November 12, 2021

PCN1098: Product Change Notification for Littelfuse Discrete SOT-227B package – Introduction of Laser Marking in Portugal Assembly Location

Figure 1: INKJET marked SOT-227B (old)

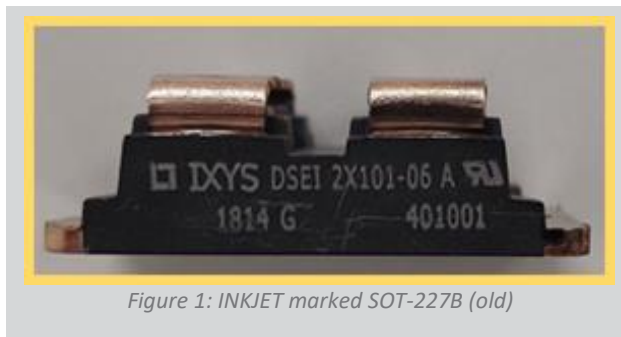
DESCRIPTION OF THE CHANGE: Starting from December 1st, 2021 the marking of the SOT-227B package will change from inkjet marking to laser marking. A comparison can be seen in **Figure 1** and **2**:

Figure 2: LASER marked SOT-227B (new)

Form, fit, function changes: No Fit/Form/Function change with the new LASER marking.

Figure 3: SOT-227B marking description

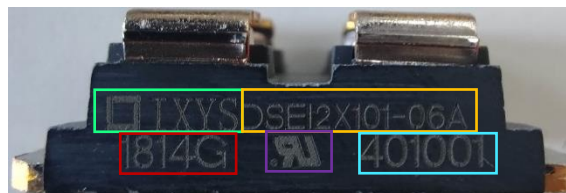
A description of the marking is given in Figure 3
